SITE PLAN WITH WAIVERS FOR METCO LANDSCAPE

Maintenance Facility Site Plan
Amendment

METCO LANDSCAPE INC.
Maintenance Facility Site Plan Amendment
17603 E. 23rd Avenue Aurora, Colorado

Maintenance Facility Site Plan Amendment
Sheet Title:
ELEVATIONS
AMENDMENT
Sheet Number:

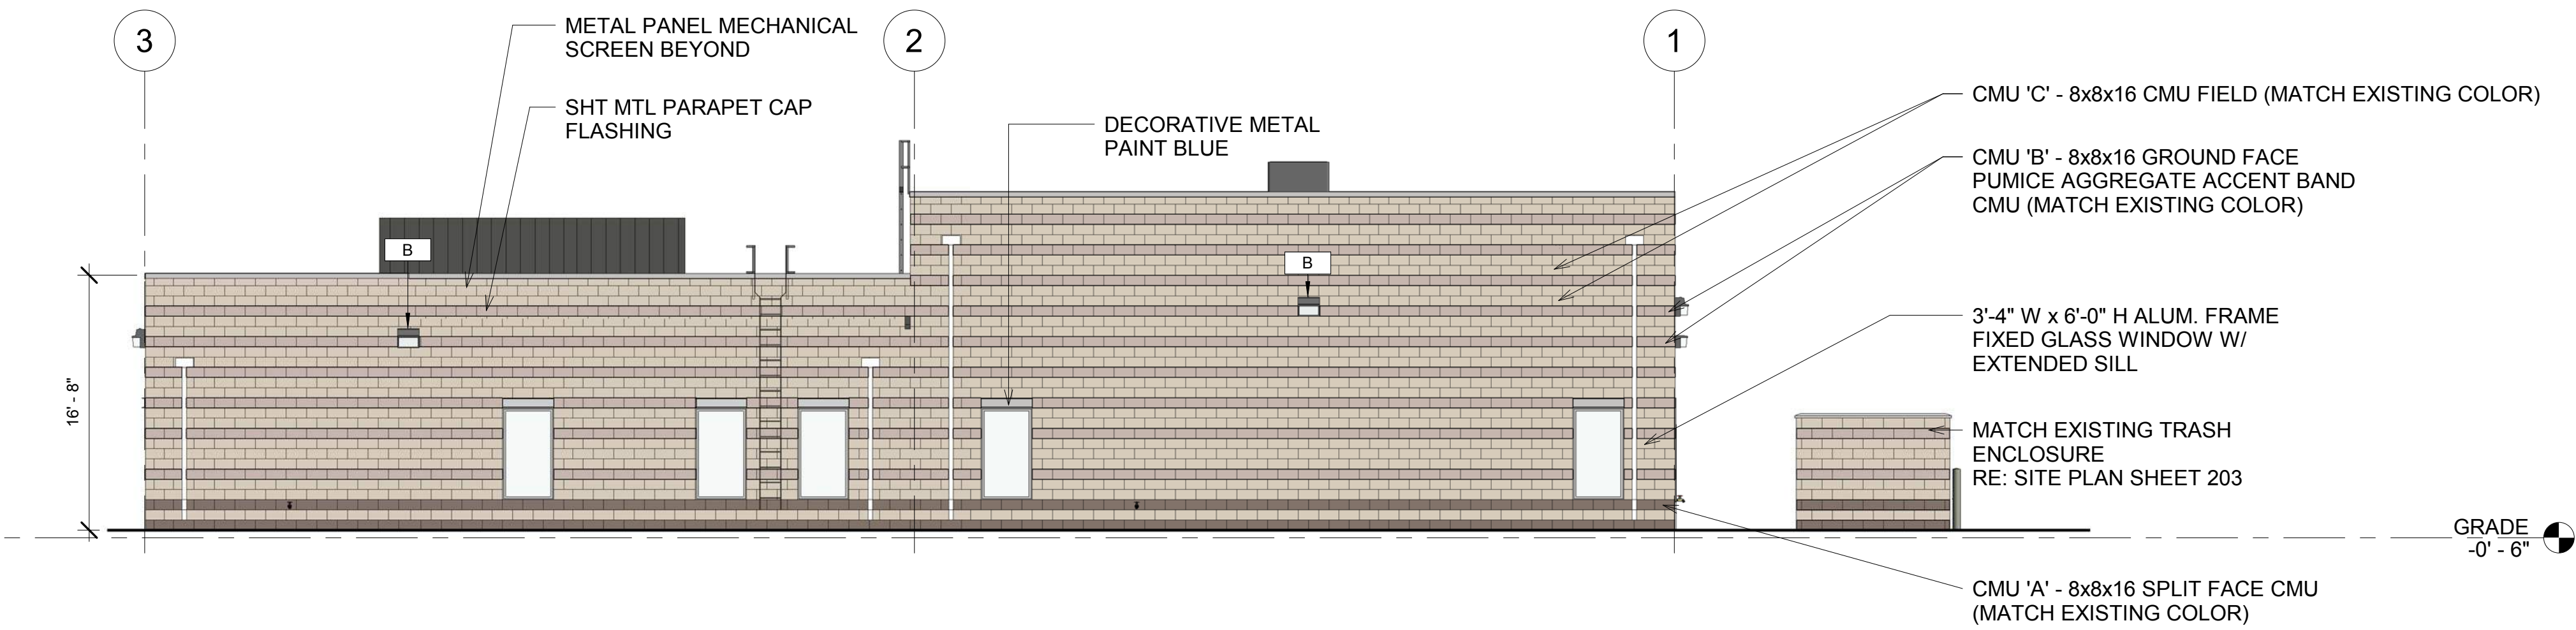
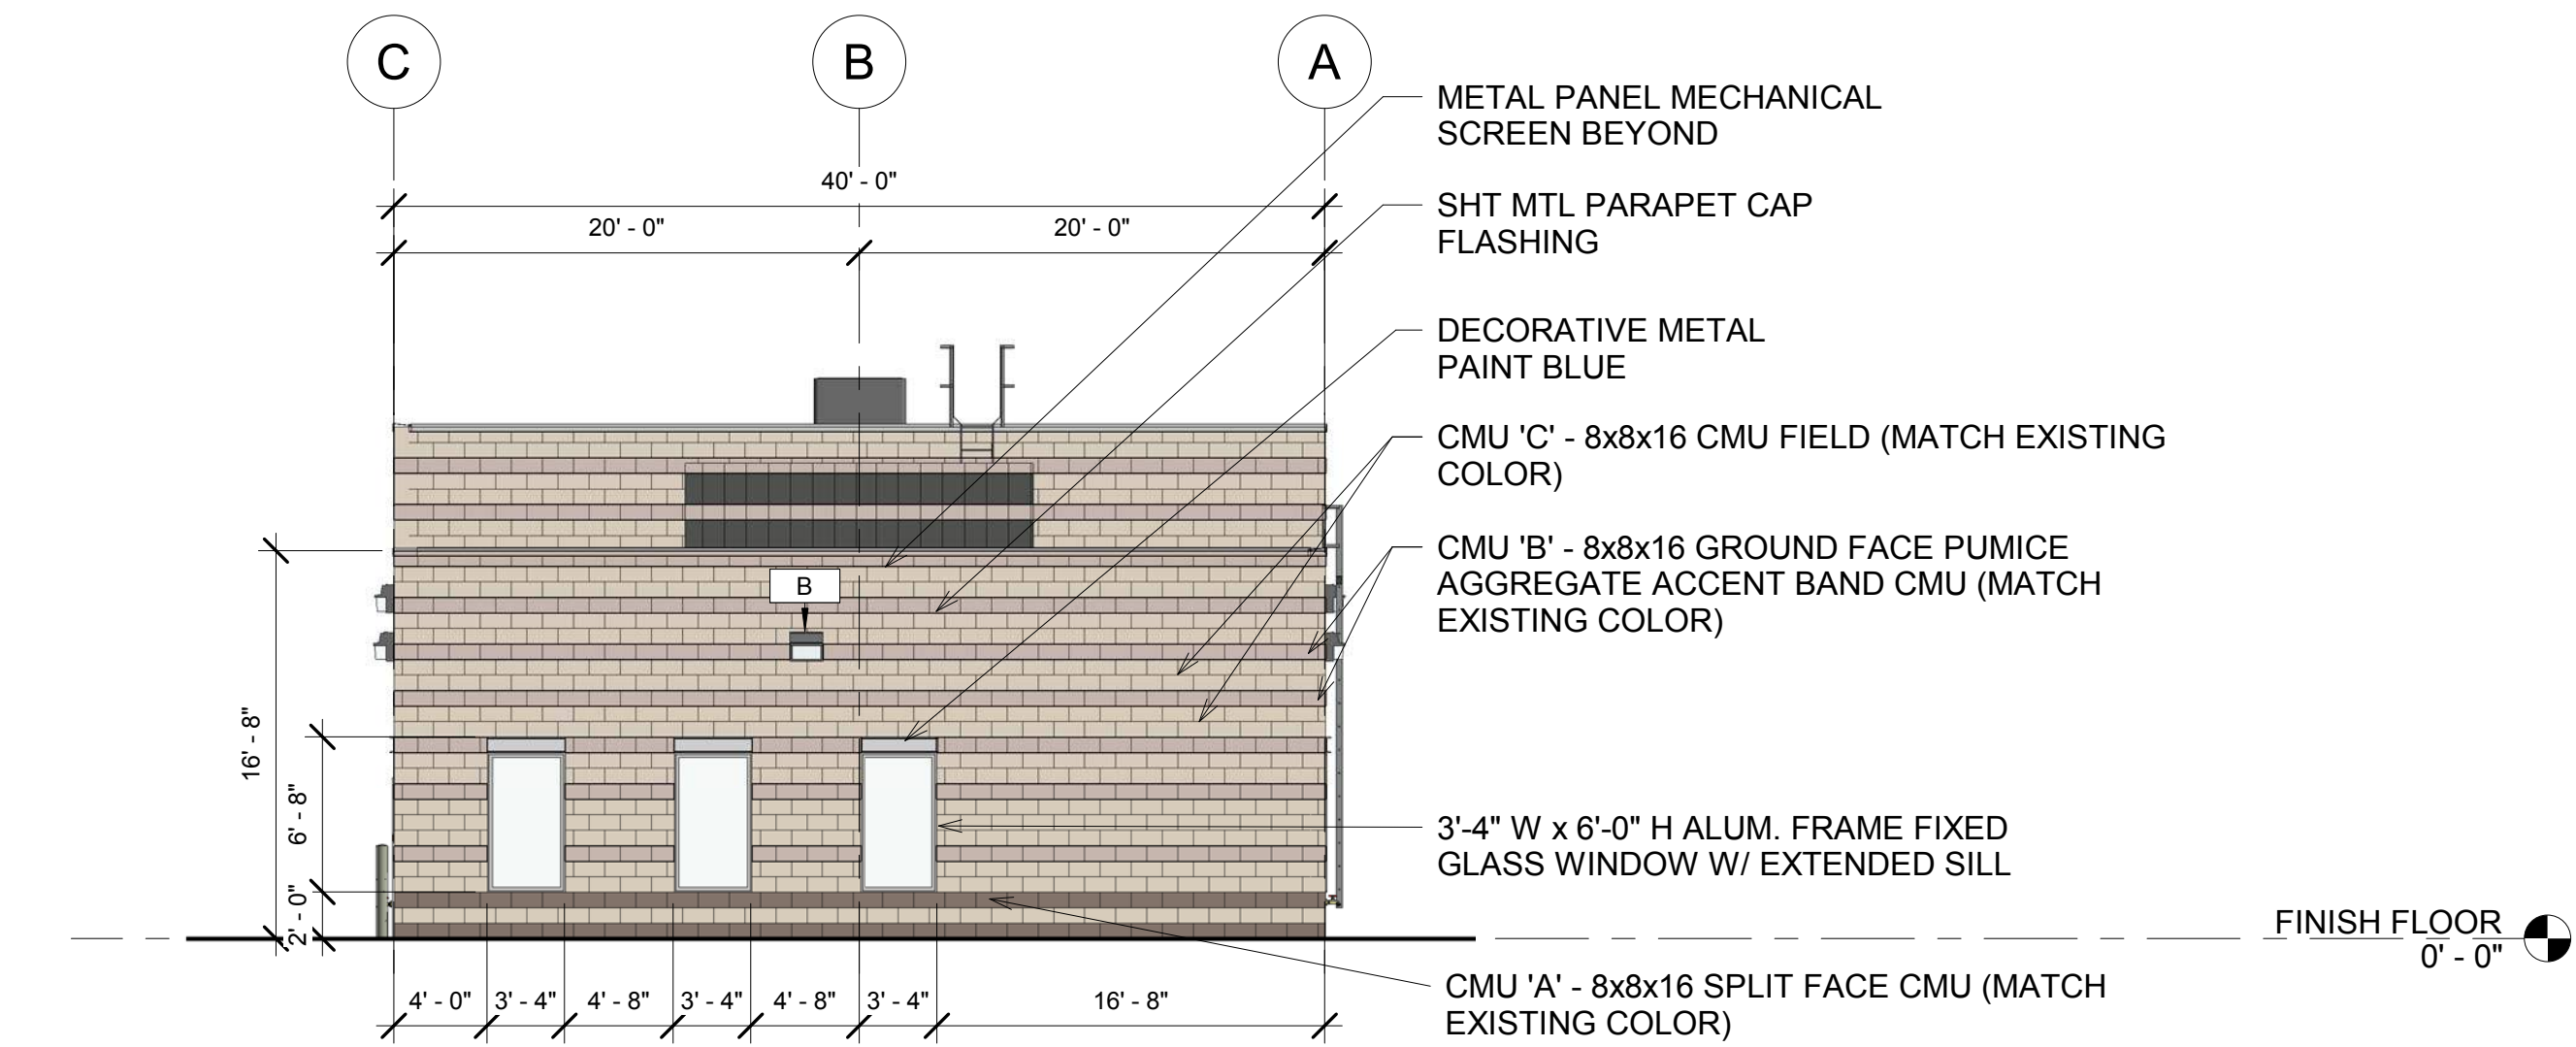
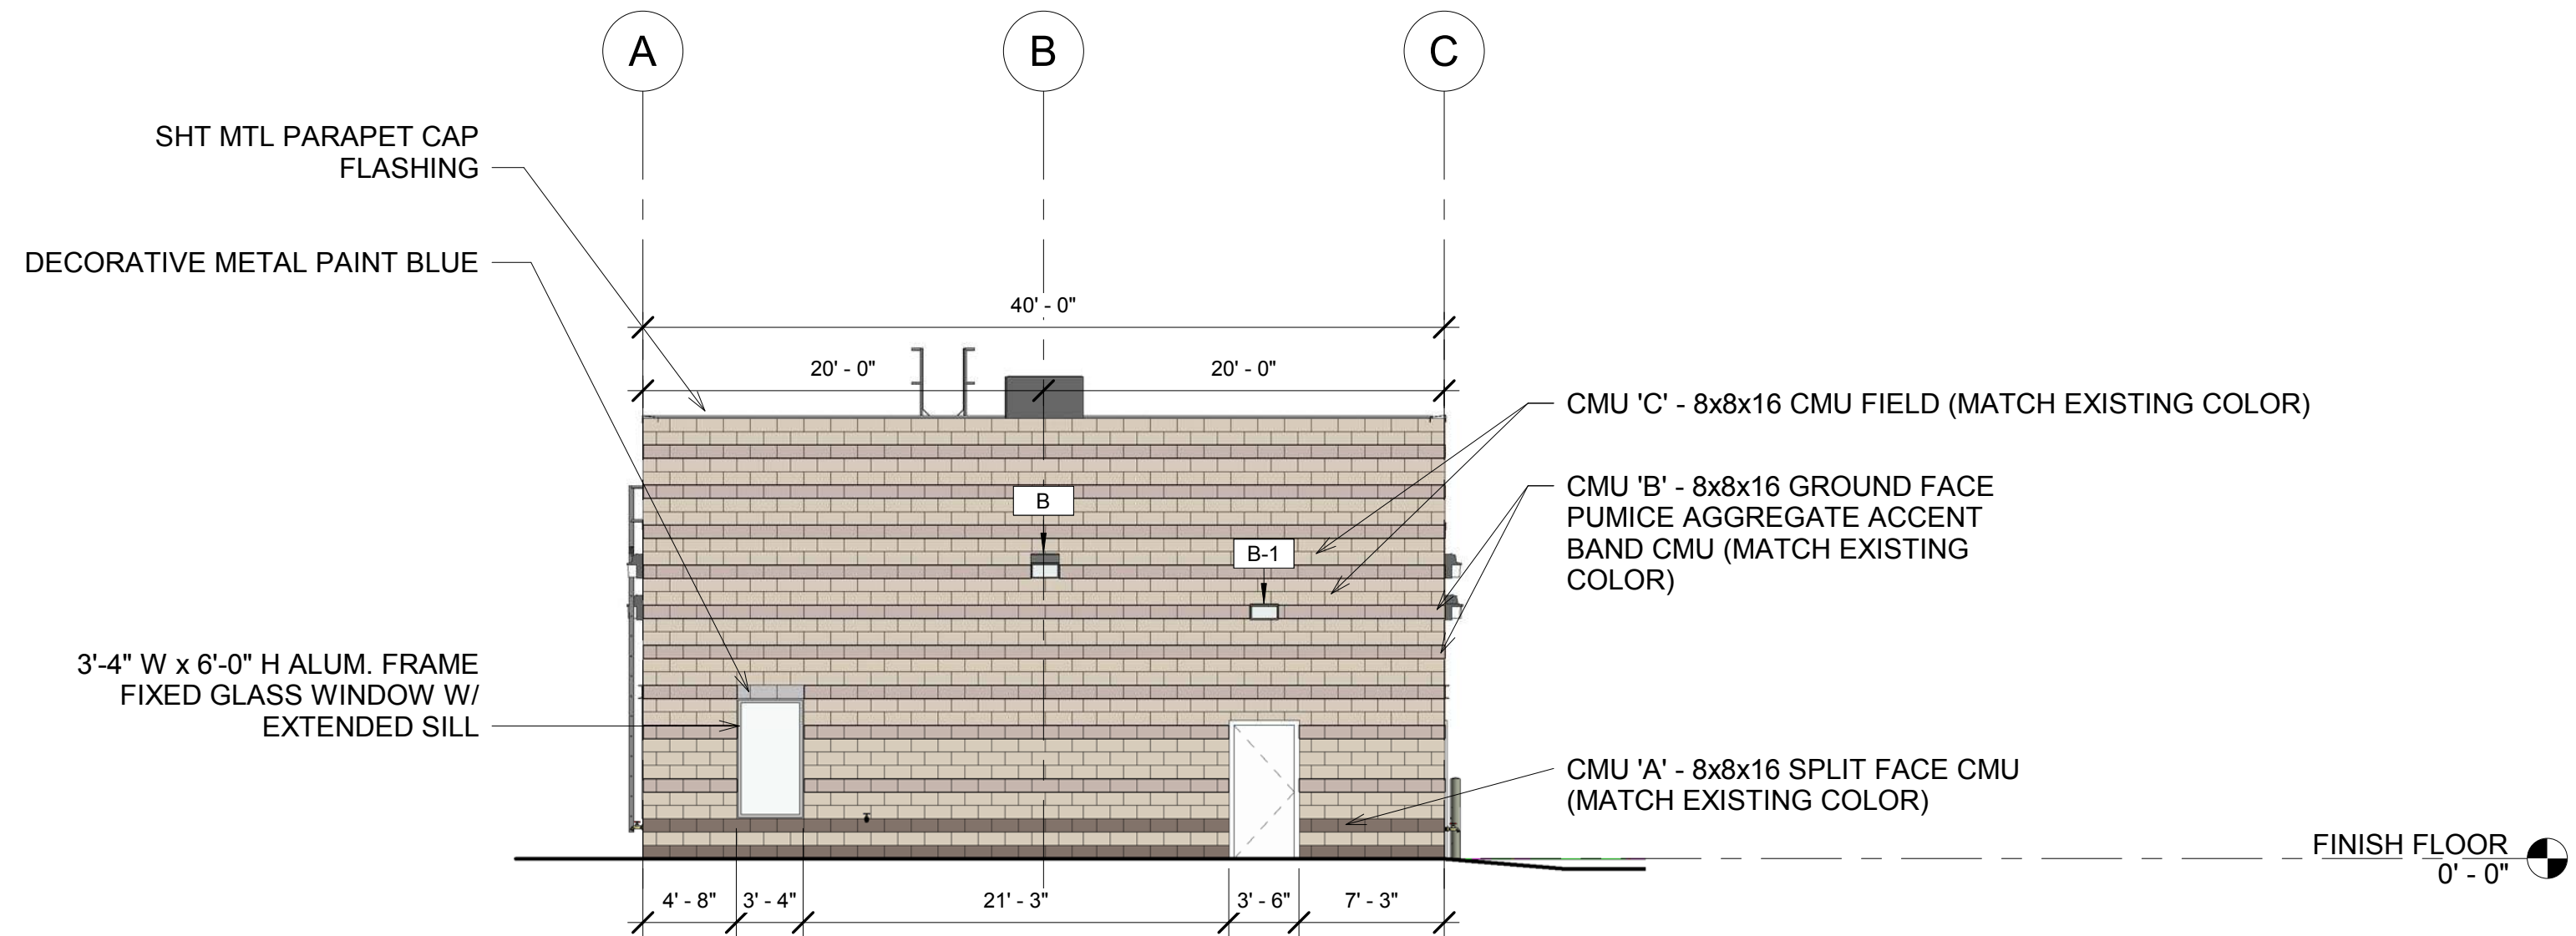
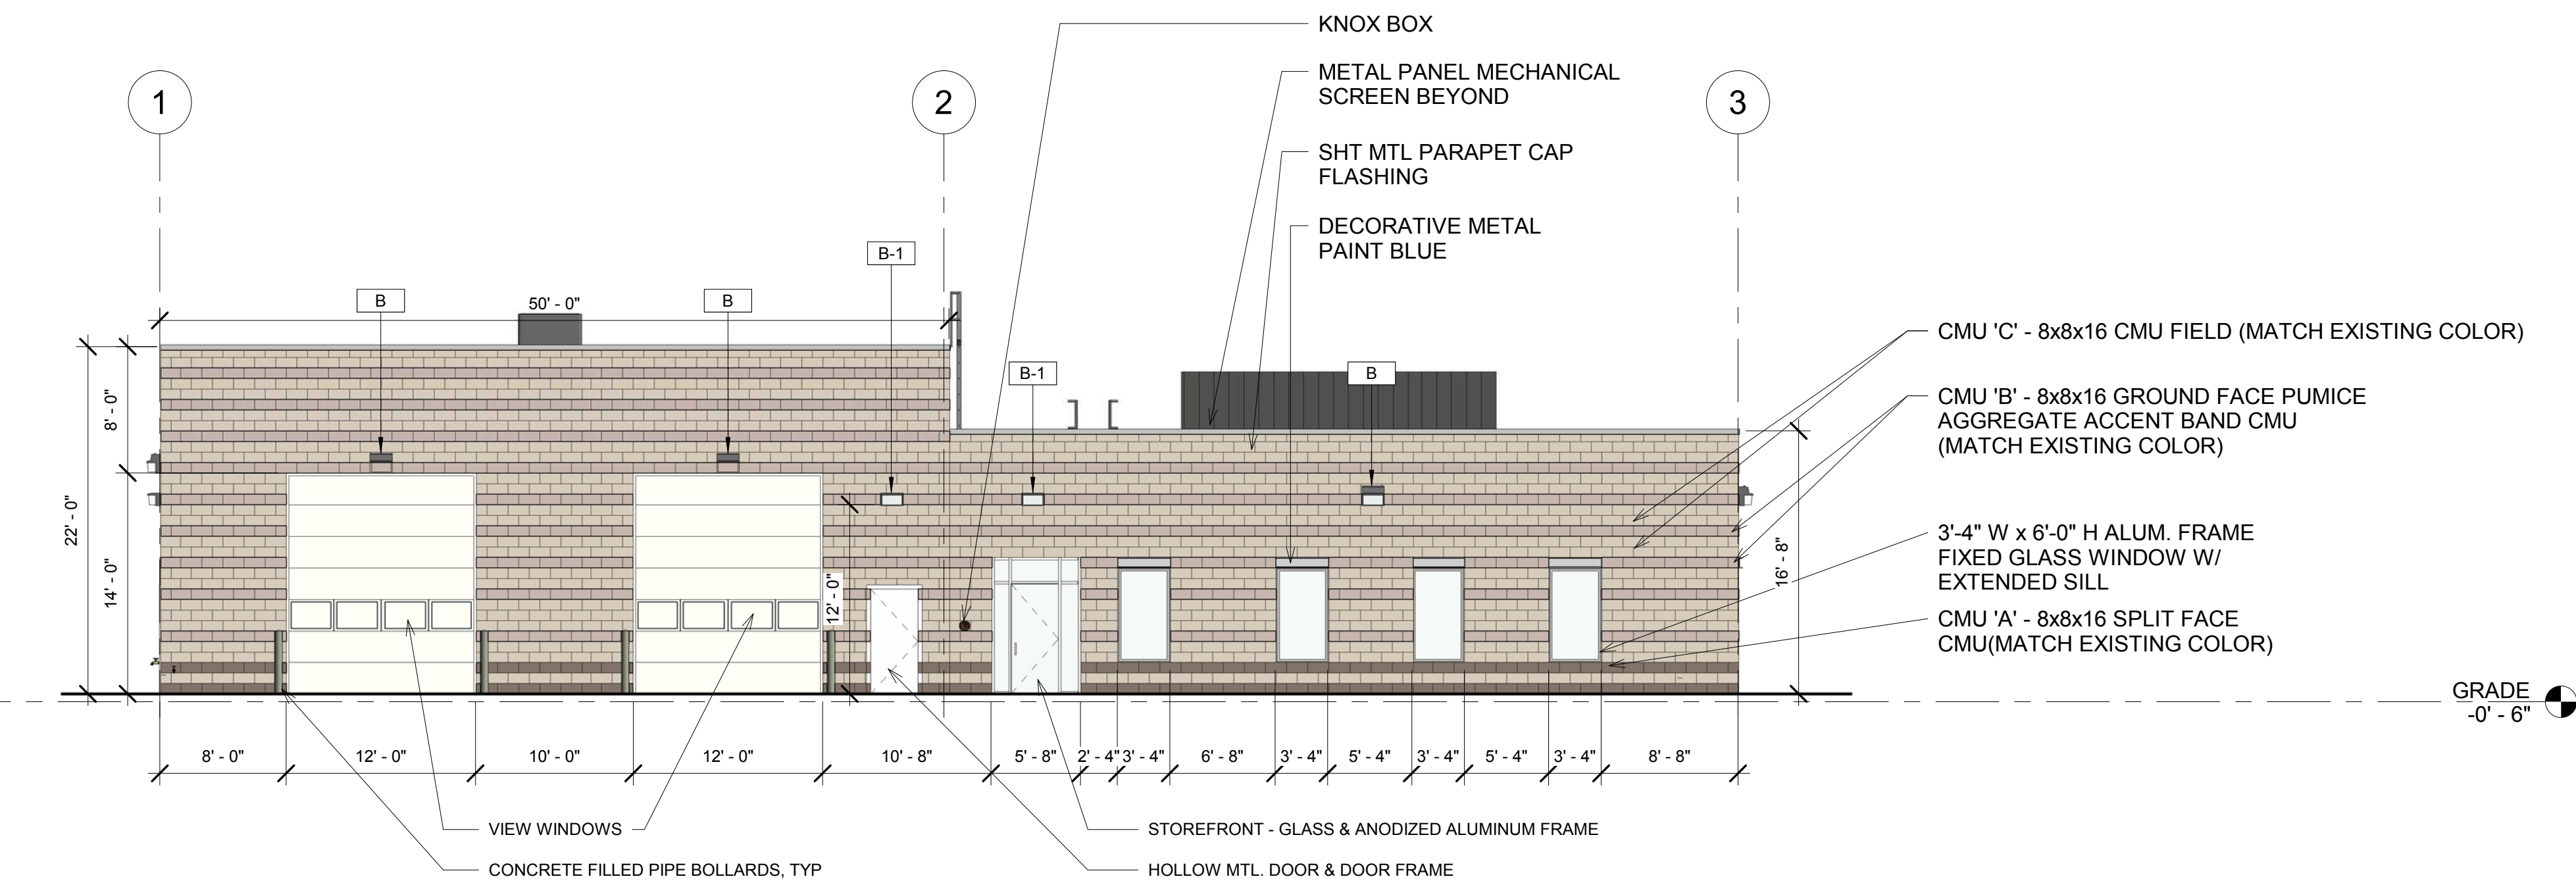
Revise this note to read "sheet
7 of 16"

Please only reference this minor amendment once in the amendment border block. The date of the amendment should be consistent throughout the pages. Please use 7/26 as it has been referenced as the amendment date on all previous pages. Do not include revision dates and submissions within this amendment process. Only one date should be referenced. Delete the 9/20 submittal line from this block.
